Burrendong Wind Farm

Amendment Report

Ark Energy

Figure 3-8: Amended Project Layout - Access Track Realignment

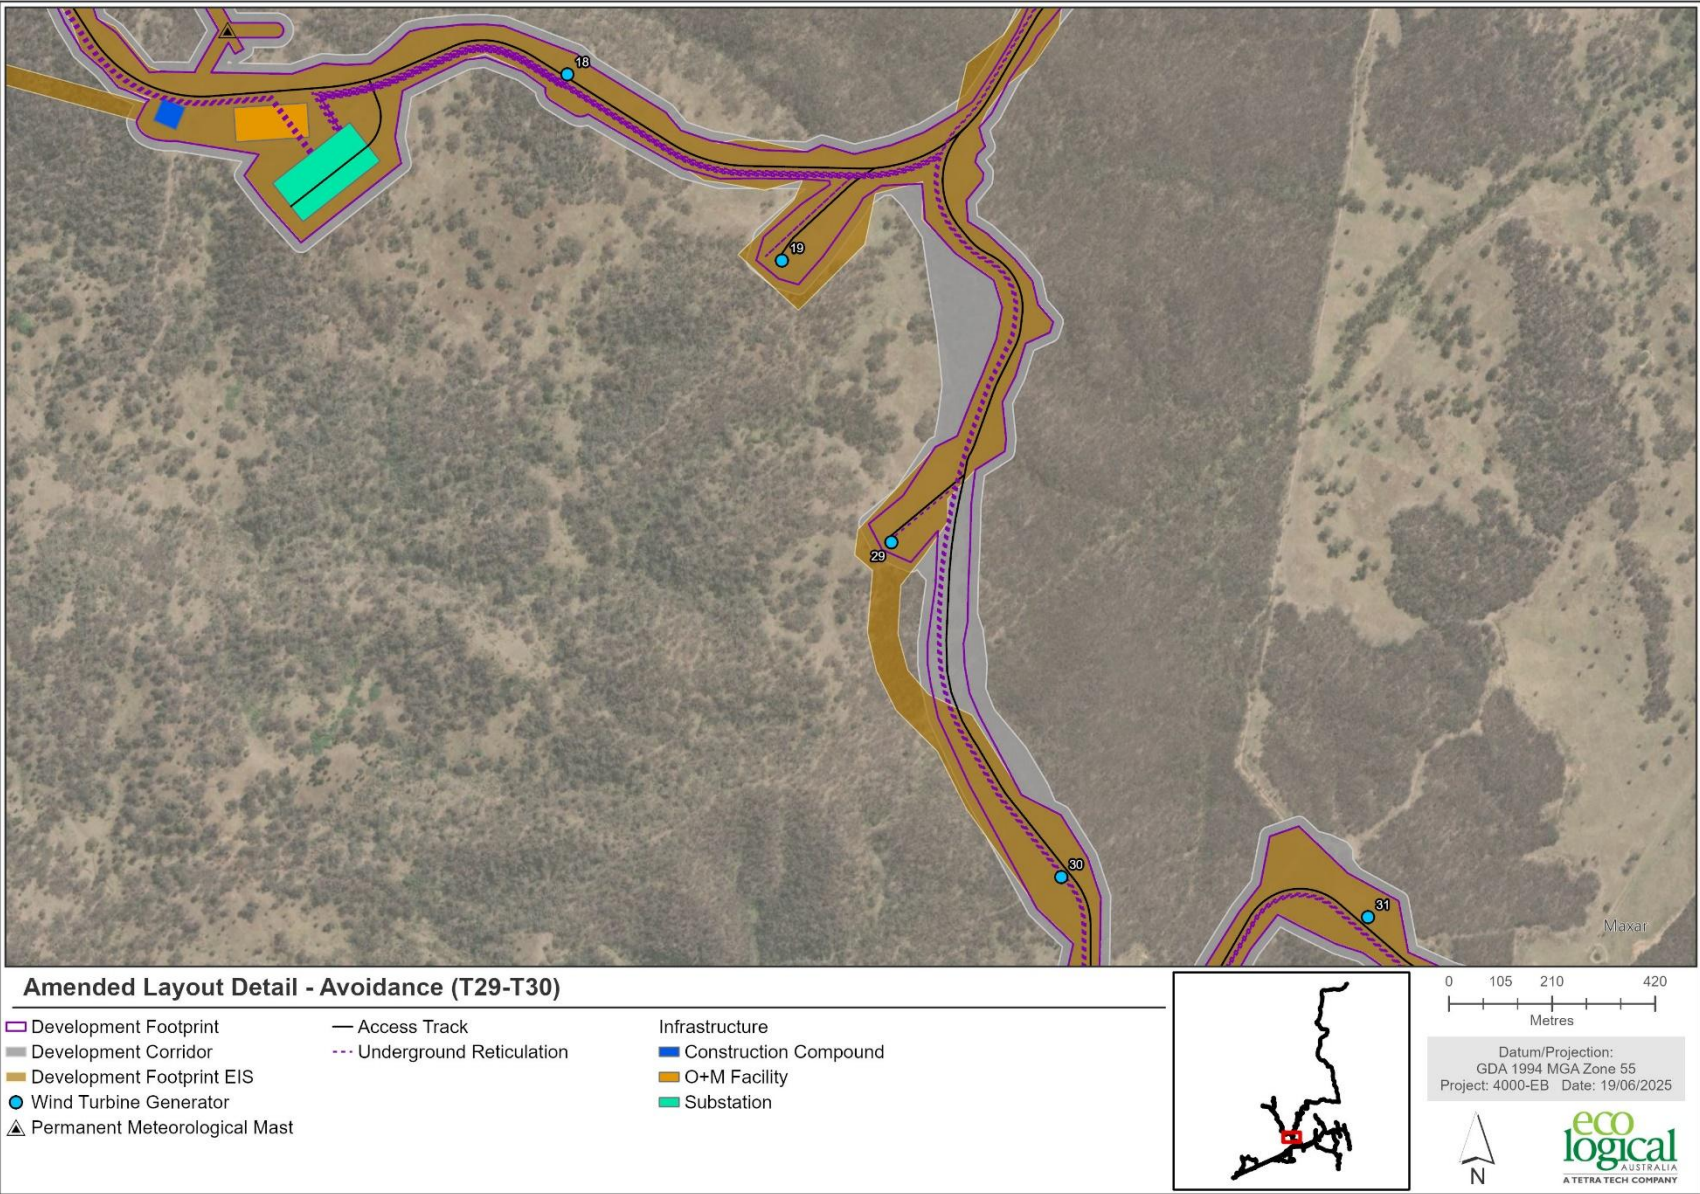
- Realigning sections of access track between WTG 29 and WTG 30 (Figure 3-8) and adjustment of access track and WTG hardstand orientation at WTG 49 (Figure 3-9)

Figure 3-10: Amended Project Layout – Southern Transmission Line

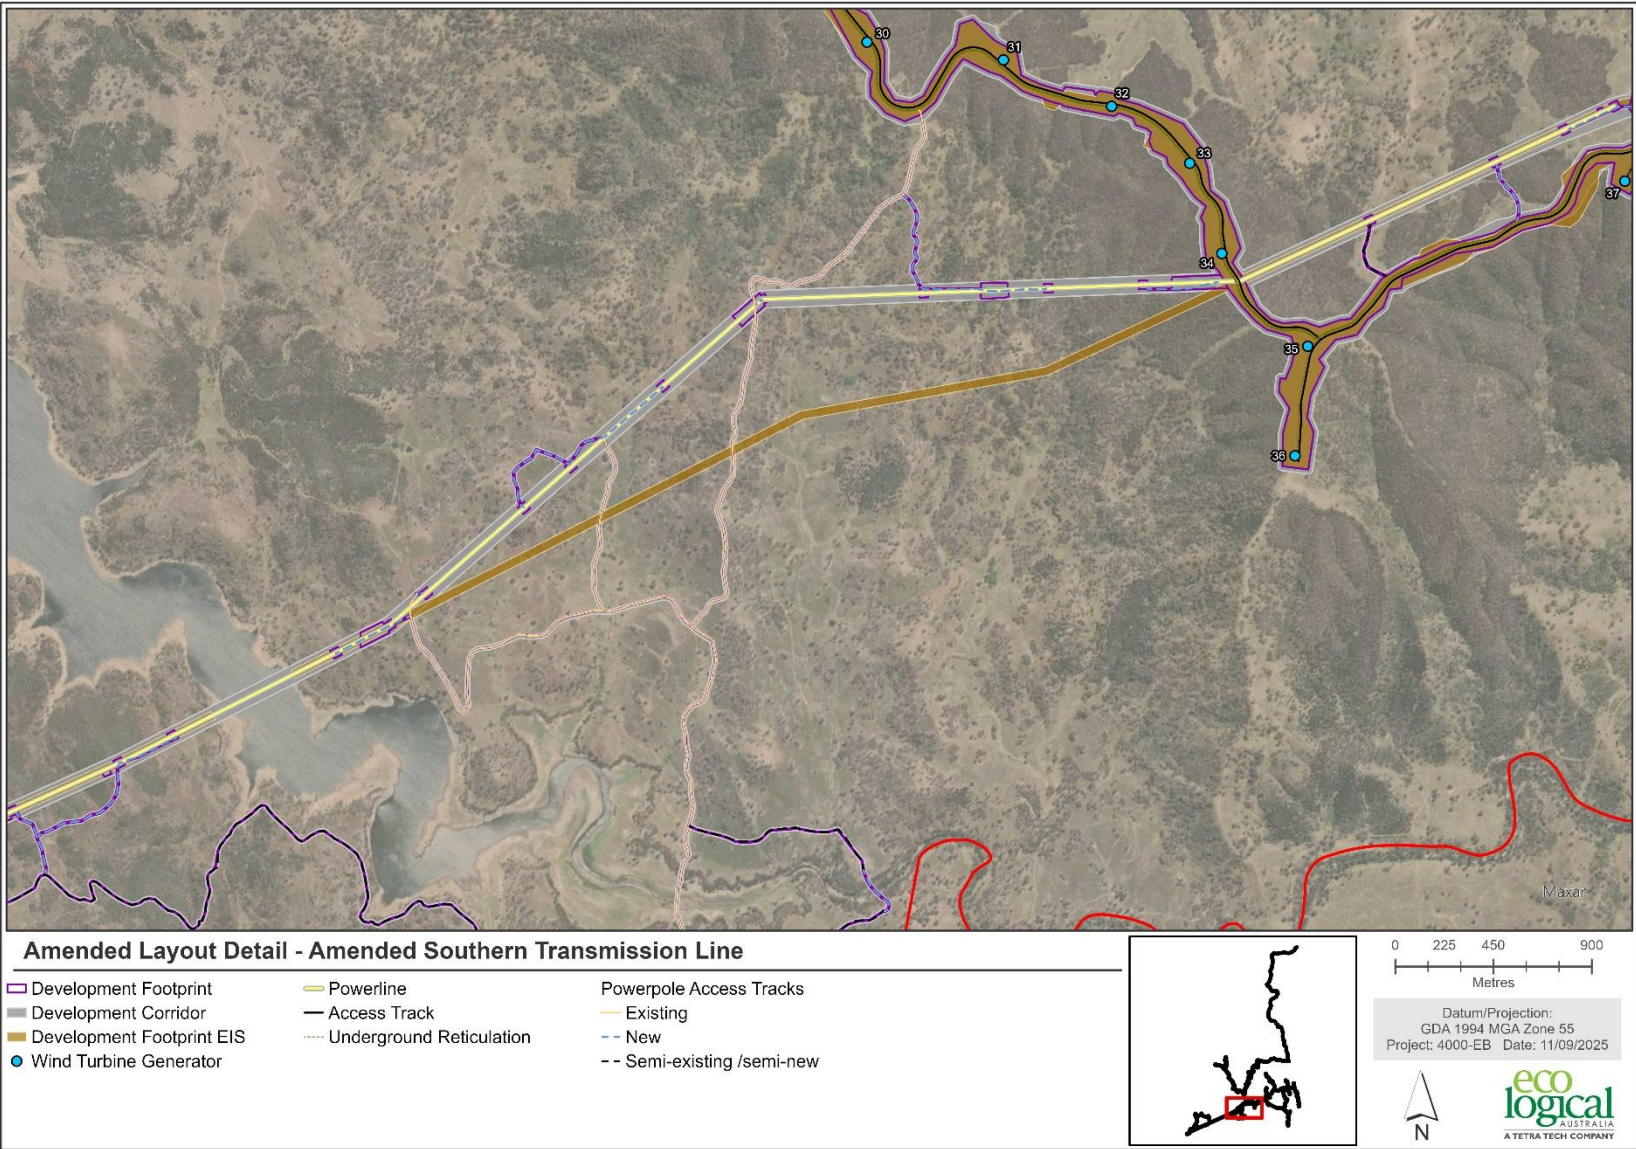
- Incorporating the TWAF within the area assessed for the construction compound (Figure 3-7)
- Adjustments and refinement of the wind farm 330 kV powerline (Figure 3-10) as follows:

The use of existing farm tracks ensures efficient construction access while reducing vegetation clearing and ground disturbance across the Project Site (Figure 3-10).

Figure 3-11: Concept strategic design of Goolma Road / Twelve Mile Road Intersection

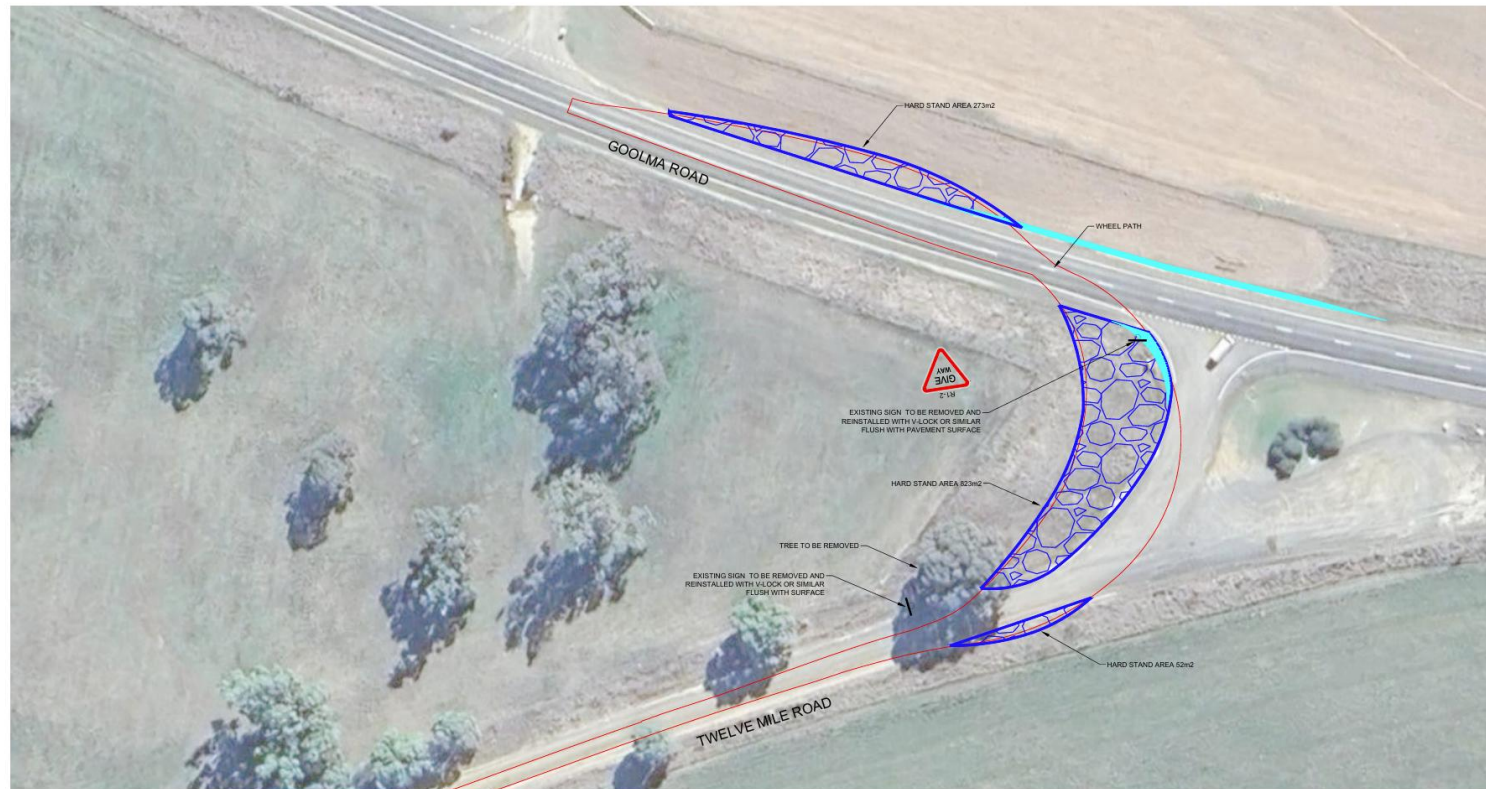
The proponent commissioned a strategic design (EMM, Appendix H.2) that details both required upgrades and identifies additional hardstand areas. These areas have been incorporated into the revised Project Development Footprint and assessed for biodiversity (Appendix F), heritage (Appendix L.2), and noise and vibration impacts (Appendix E.2).

Figure 3-11 presents the EMM strategic design. The complete strategic design package is provided in Appendix H.2.

Figure 3-14: Subdivision Water NSW Lot 16

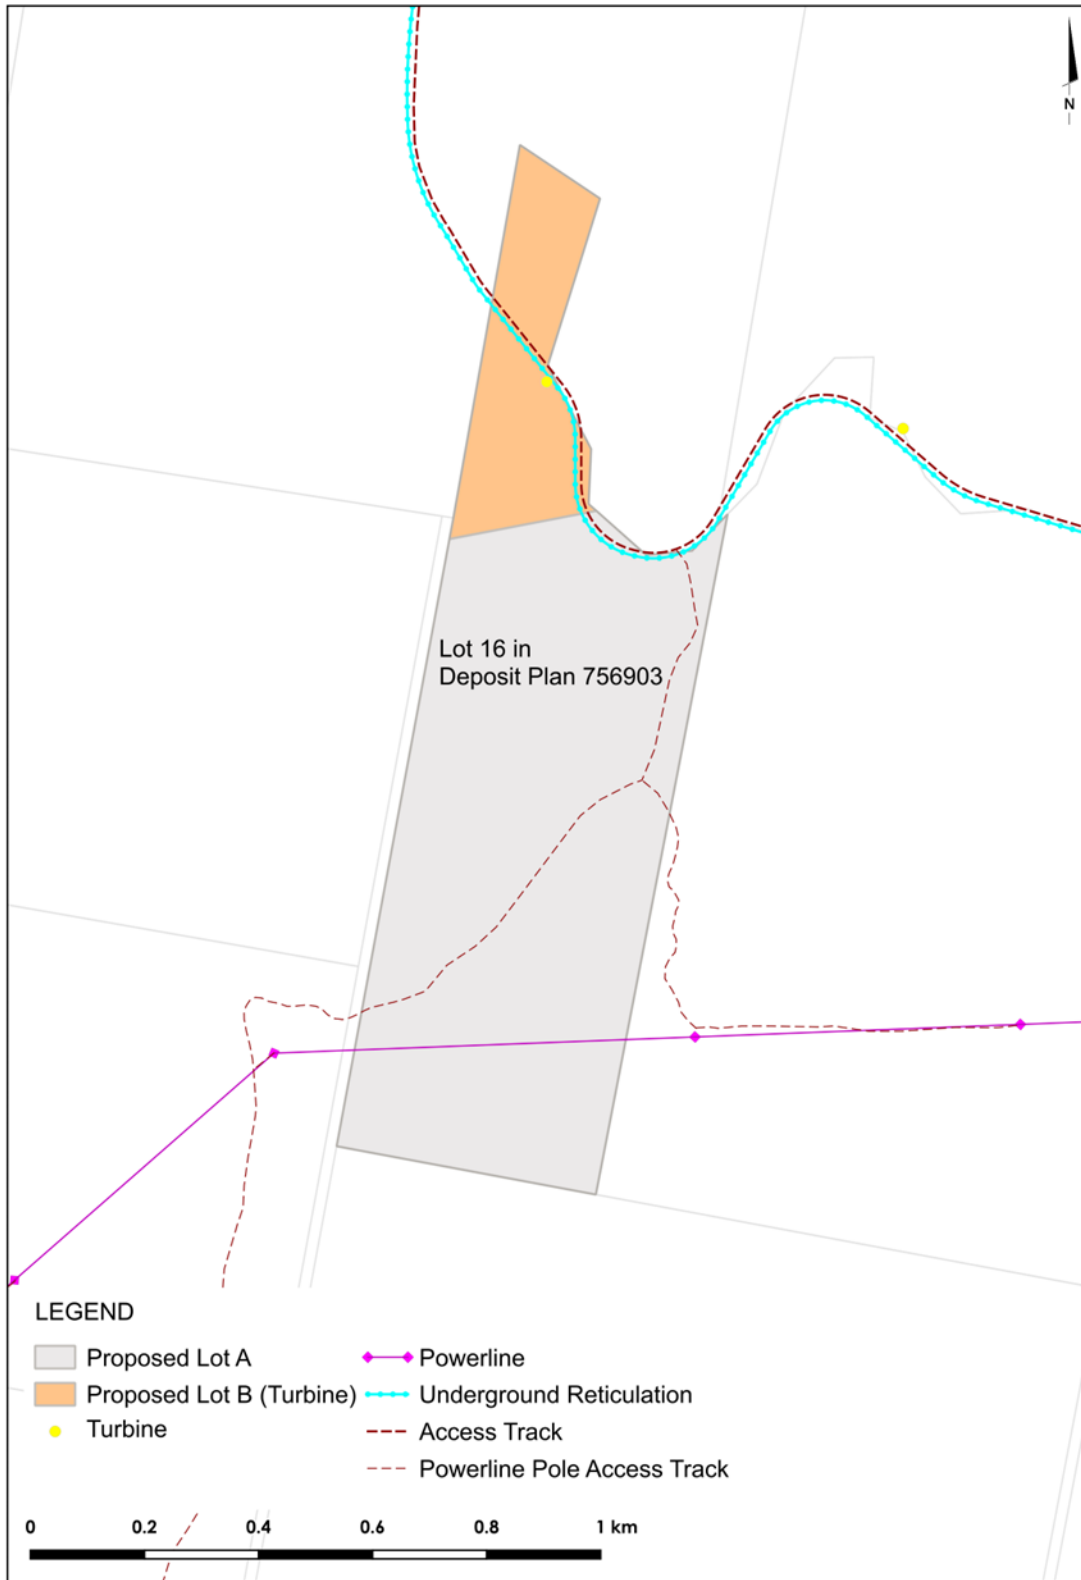
Following submission of the EIS, Water NSW has requested that three of the land parcels that host WTGs be sub-divided to provide greater flexibility for the land tenure arrangements for the Phoenix PHES project infrastructure proposed to be located on the same two parcels of land. The three parcels of land are and are shown on Figure 3-14 to Figure 3-16:

Figure 6-9: Telecommunication Link Profile

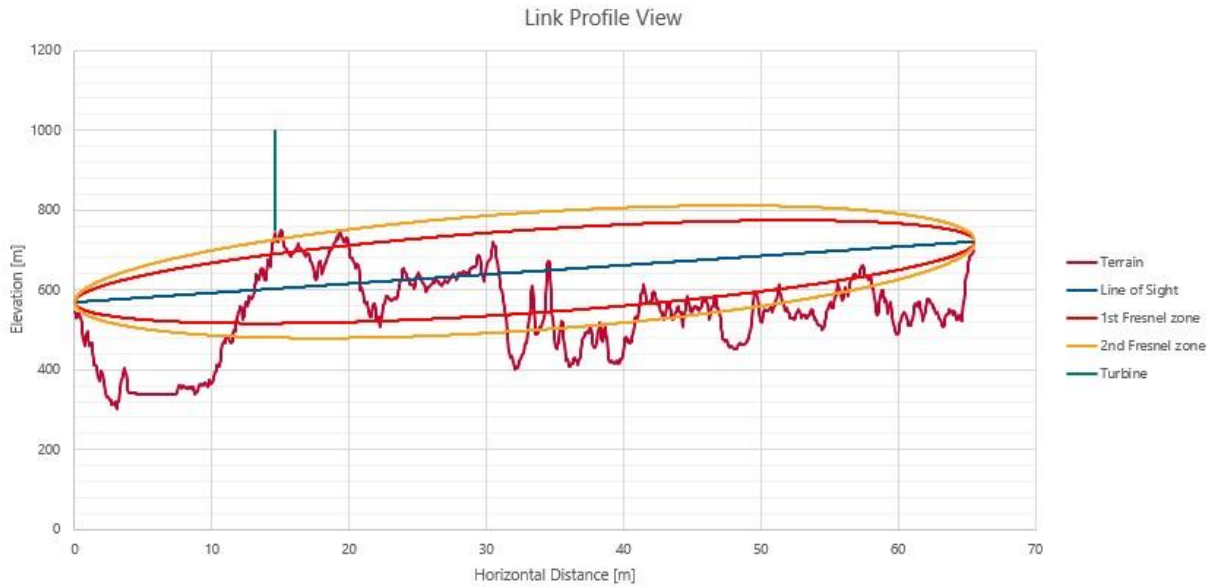
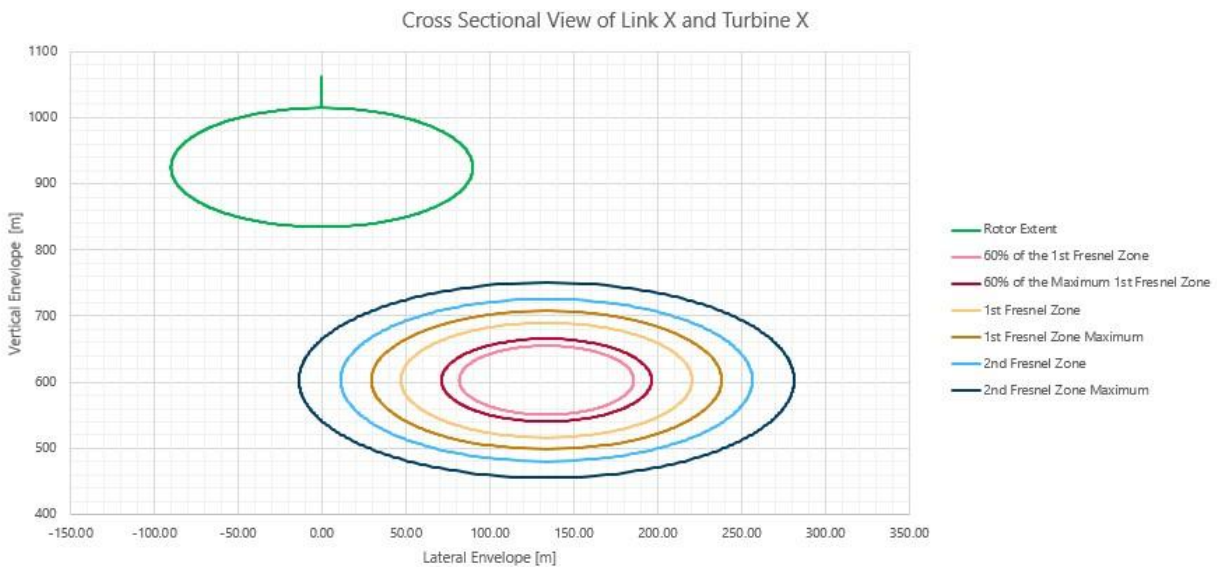
The antenna heights at Burrendong Dam and Mount Bocoble were previously assumed at 0 m in height. However, following submissions received from Water NSW, it has been established that the transmitter heights are 25 m at Burrendong Dam and 35 m at Mount Bocoble. Additional analysis has been completed to determine if the WTGs would impinge on the telecommunications link. As shown in Figure 6-8, two proposed wind turbines are near this link. One WTG appears to impinge on the link from a bird eye’s view, however after a line of sight and topography analysis, the WTG is found to be positioned well above the 1st Fresnel zone of the link as shown in Figure 6-9 and Figure 6-10.

The updated assessment has concluded there are no additional impacts beyond those identified within the EIS. The conclusions of the updated assessment remain consistent with the telecommunication impact assessment submitted as part of the EIS. Water NSW have been notified of this additional analysis.
